Subject: MHI's Response to US-APWR DCD RAI No. 788-5883 Revision 3 (SRP 15.1.5)

MHI's Response to US-APWR DCD RAI No. 788-5883 Revision 3
(SRP 15.1.5)

RAI NO.: NO. 788-5883 REVISION 3
SRP SECTION: 15.01.05 - STEAM SYSTEM PIPING FAILURES INSIDE AND OUTSIDE OF CONTAINMENT (PWR)
APPLICATION SECTION: 15.1.5
DATE OF RAI ISSUE: 7/26/2011

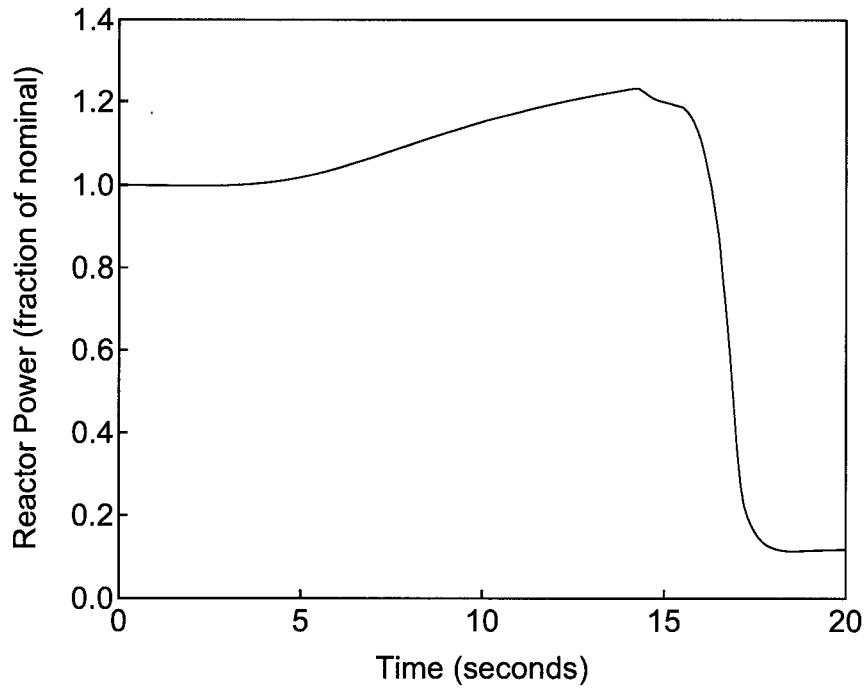
Three different cases are analyzed for the main steam line break event in DCD 15.1.5. While the first two were individual runs, Case C represents a series of runs to address variations in break size and power level. From Figure 15.1.5-26, it appears the DNBR limiting event for Case C is an approximately 0.4 ft² break initiated at 100% power. Because this Case C data point appears to be more limiting than either Case A or Case B, include more details of this particular Case C run in the DCD to demonstrate the acceptance criteria of SRP 15.1.5 are met. Include a sequence of events that identifies mitigating system actuation and time related variations of key parameters (as was done for Case A and Case B).

Event Description	Case C*1 Time [sec]
<u>Steam pipe rupture occurs</u>	<u>0.0</u>
<u>Over power ΔT analytical limit reached</u>	<u>8.0</u>
<u>Reactor trip initiated (rod motion begins)</u>	<u>14.0</u>
<u>Minimum DNBR occurs</u>	<u>14.7</u>
